RE: 1187 Solano, environmental, model deed restriction

Subject: SLIC Case Albany 1-Hour Cleaners, 1187 Solano Avenue, Albany, CA

Subject: SLIC Case Albany 1-Hour Cleaners, 1187 Solano Avenue, Albany, CA – Work Plan Approval

Toxics Case No. 100 100 157, Albany 1-Hour Cleaners, Dry Cleaning Facility at

attachment: site location plan

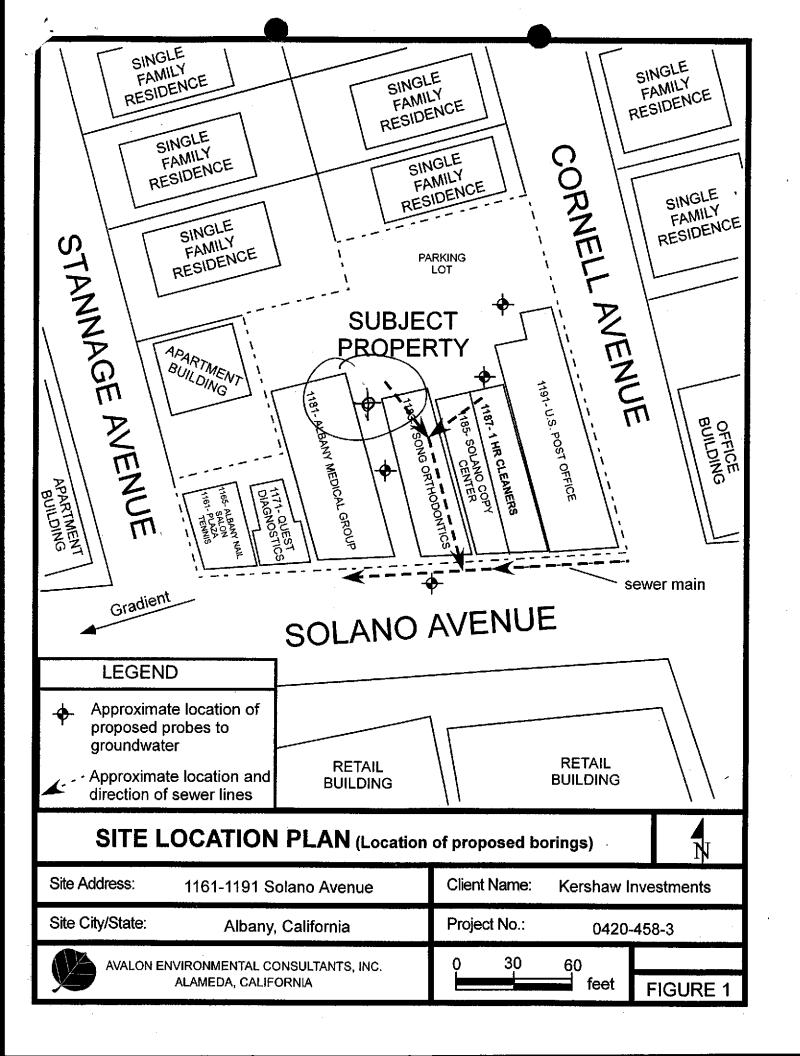
No additional evaluation of the likely groundwater flow direction at the site was presented in the revised workplan. An additional groundwater sampling locations appear necessary west of the site. We recommend including a boring in the location shown on the attached figure.
